APPLICATION NO.	FILING DATE	FIRST NAMED INVENTOR	ATTORNEY DOCKET NO.	CONFIRMATION NO.
10/584,357	06/26/2007	Alex Hogg	DEP5246USPCT	9482

Office Action Summary	Application No. 10/584,357	Applicant(s) HOGG ET AL.	
	Examiner MATTHEW LAWSON	Art Unit 3775

DETAILED ACTION

Fig. 2

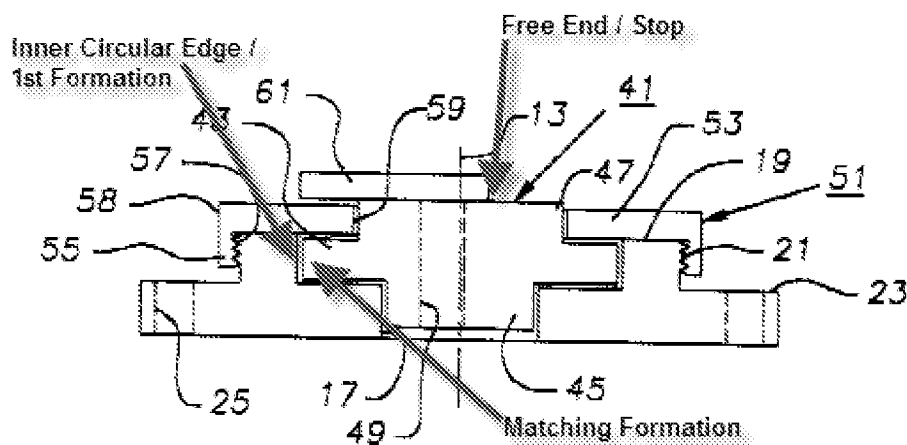
Regarding claims 1-6, Umber et al. disclose a reamer guide for reaming a cavity within a tibia, the reamer guide comprising a plate (15, figure 1) having a circular aperture (17, figure 2) therethrough and defining a plane (figure 2), and a disc (43,

figure 2) rotatably mounted in the aperture, the disc having a bushing (49, figure 2) therein defining a reamer axis (13, figure 1) offset from the center of the disc for receiving a reamer (71, figure 3) in use and in which the disc is capable of rotation about an axis transverse to the plane of the plate (column 3, lines 31-37), and the plate further includes at least one mounting hole (25, figure 2), wherein the plate further comprises an inner circular edge (see figure below) having a first formation (see figure below) therein, and wherein the periphery of the disc has a matching formation (see figure below) that engages with the first formation to retain the disc within the aperture. The circular formation is a shoulder (see figure below) and the matching formation is a flange (see figure below), wherein the reamer axis (13, figure 1) is angled toward the axis of rotation (figures 1-2, 4, and column 2, lines 49-51). The bushing further has a free end (top surface, see figure below) and includes a stop (top surface acts as a stop when the reamer contacts the surface, see figure below) located toward a free end for limiting travel of a reamer into the bushing.

8. Regarding claims 7-8, and 10 Umber et al. disclose a reamer guide (figures 1-2, and 4) for reaming a cavity within a tibia, the reamer guide including a plate (15, figures 1-2, 4) having a circular aperture (17, figure 1) therethrough and defining a plane (figure 1) and a disc (43, figure 2) rotatable mounted in the aperture, the disc having a bushing (49, figure 2) therein defining a reamer axis (13, figure 1) from the center of the disc for receiving a reamer (71, figure 3) and in which the disc is capable of rotation about an axis transverse to the plane of the plate, the bushing having an inner diameter

Fig. 3

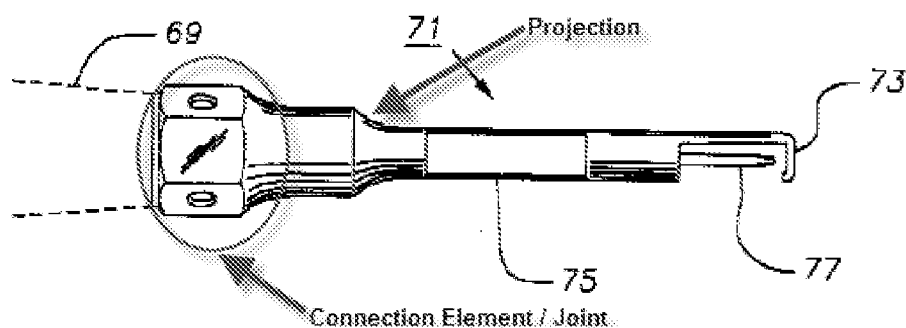
(opening/diameter of the bushing 49, figure 2 and 4) and a reamer (71, figure 3) sized to substantially match the inner diameter of the bushing. The reamer further includes a projection (see figure below) and is sized to engage with an edge of a free end of the bushing, the projection positioned a distance from a distal end of the reamer to control the depth of the cavity to be formed to correspond to a desired depth (acts as a stop member); the assembly further comprises a drive mechanism (69, figure 3) attached to the joint for rotating the reamer.
